August 12th, 2024

Technical Service Bulletin – 13

Shifter Linkage Inspection

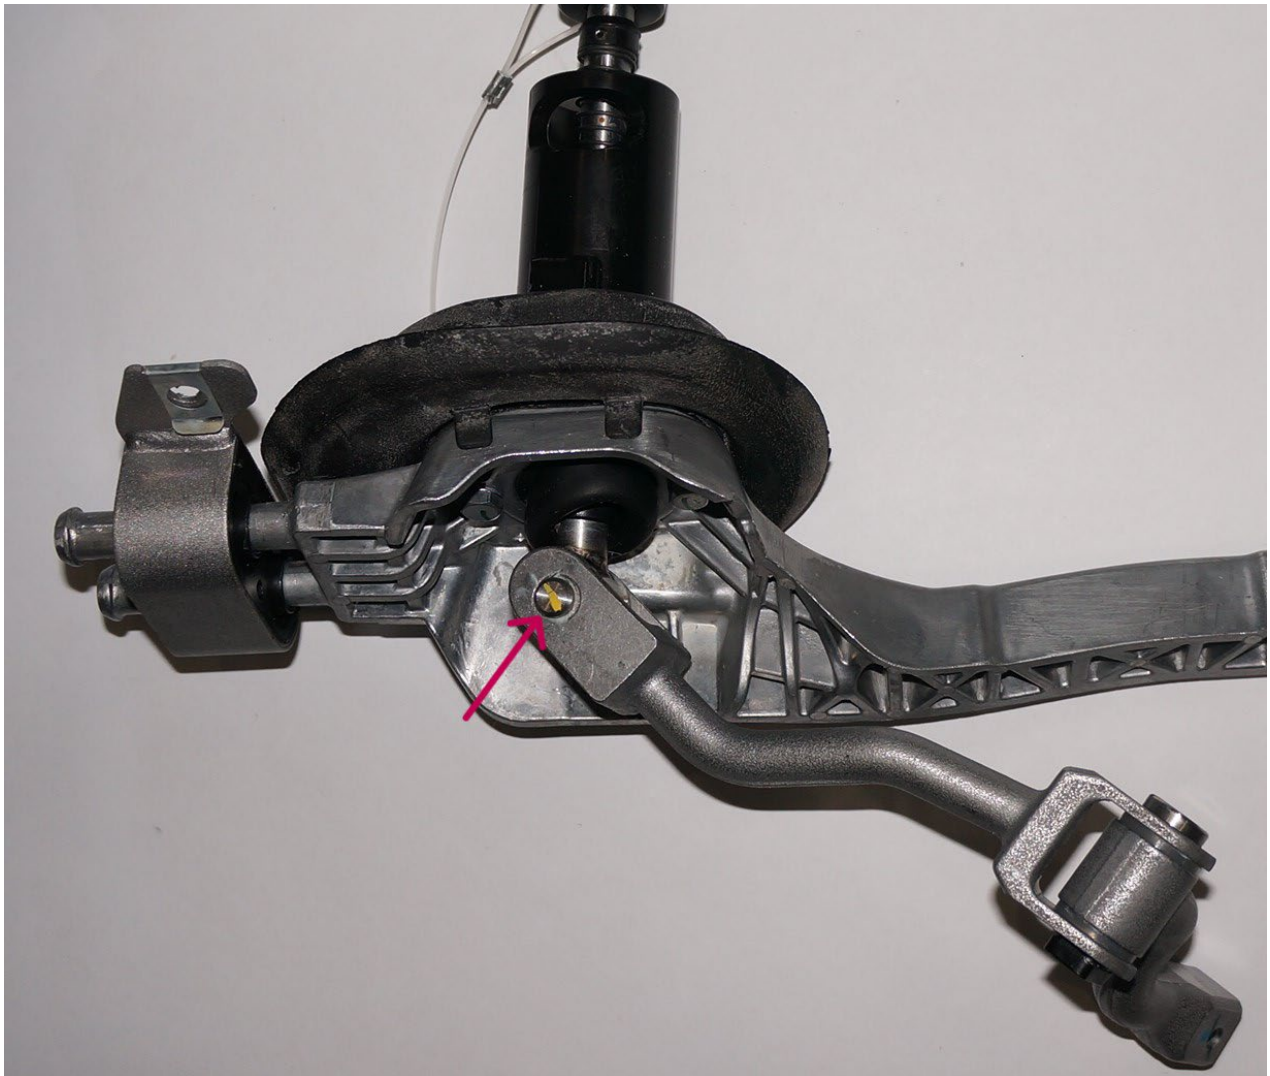
Issue: Some vehicles were built without a shifter linkage clip installed, as shown in the photo below.

Action: Install clip per photo below. If a clip is required, please contact Watson Engineering, Inc. at the following email address: sales@watsonracing.com
